P 517992-A

**ON-SITE SEWAGE DISPOSAL SYSTEM  
HOWARD COUNTY HEALTH DEPARTMENT  
BUREAU OF ENVIRONMENTAL HEALTH**

ADDRESS: 580 Obrecht Road, Sykesville

SUBDIVISION: River Park Estates

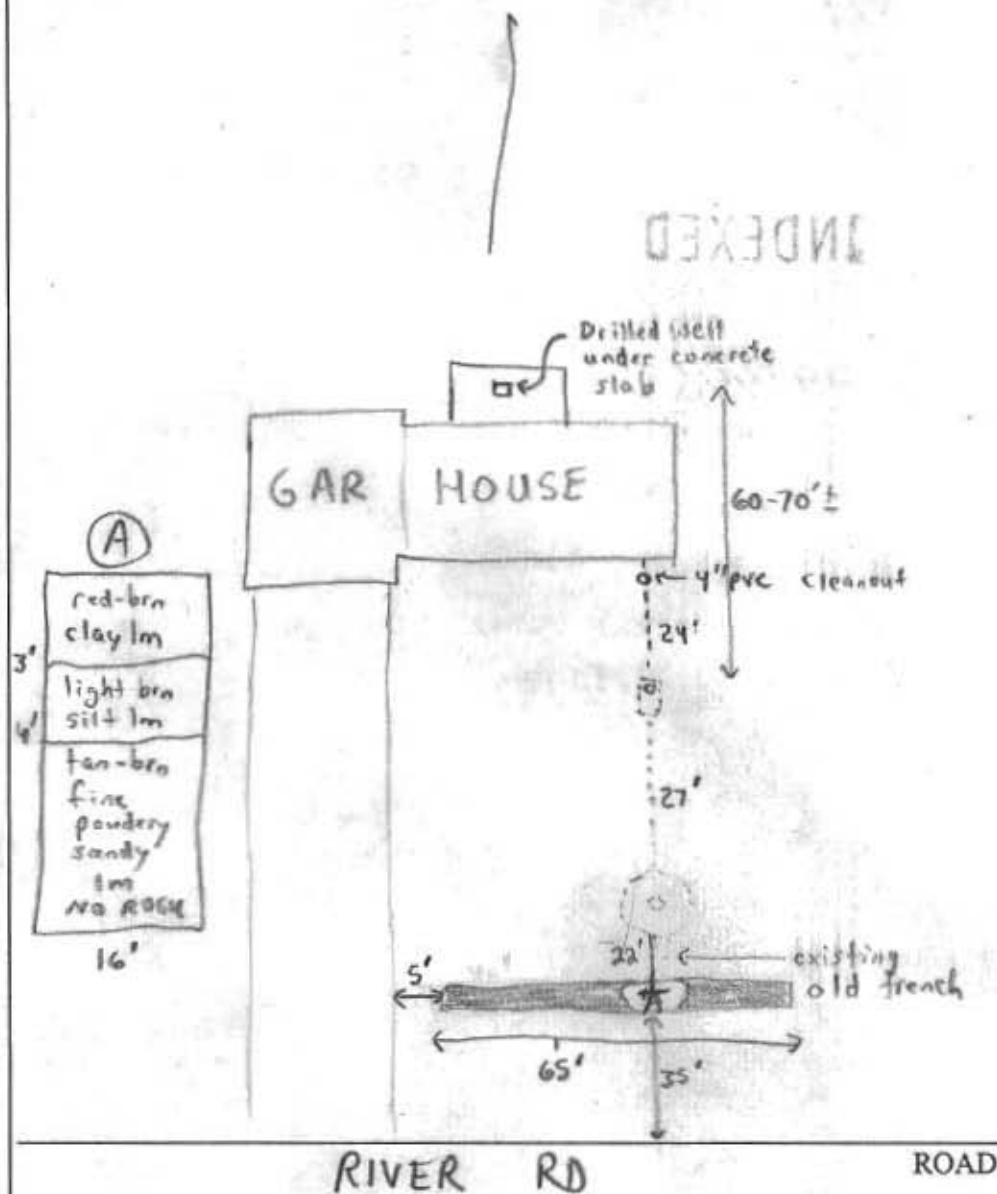
TRENCHES:	Trench to be 2 feet wide. Inlet 3 feet below original grade. Bottom maximum depth 10 feet below original grade. Effective area begins at 3-4 feet below original grade. 7 feet of stone below distribution pipe.
LOCATION:	
PURPOSE:	Existing septic system has failed. Call for inspection when ground is opened so sanitarian can recommend repair.

PRE-CONSTRUCTION 11/20/02 - MET CONTRACTOR (KENNY MAYNE) DUG PERC HOLE IN LOCATION (A) INSTALL AS DISCUSSED. A DRILLED WELL WAS OBSERVED INSTALLATION - >100' SLIGHTLY DOWNSLOPE OF PROPOSED SEPTIC BUT NOT IN DIRECT DRAINAGE PATH OK - (FA/SRK)

INSTALLATION - 11/20/02 - OK TO COVER ALL WORK - (SRK)

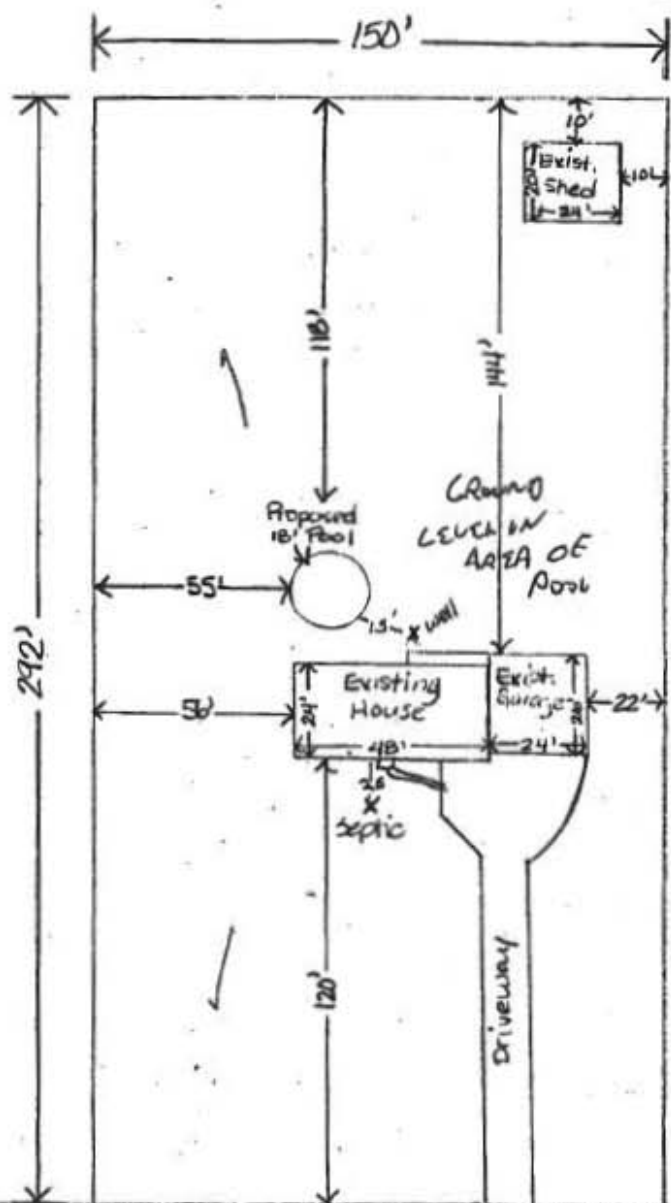
BRI SEPTIC CLEANOUT IS UNDER YARD ORNAMENT IN FRONT OF HOUSE

WELL IS CAPPED - owner says no pit, 1' from house, 7' from porch

PROPOSED POOL IS NO CLOSER TO WELL THAN

EXISTING HOUSE SEPTIC

OK TO APPROVE
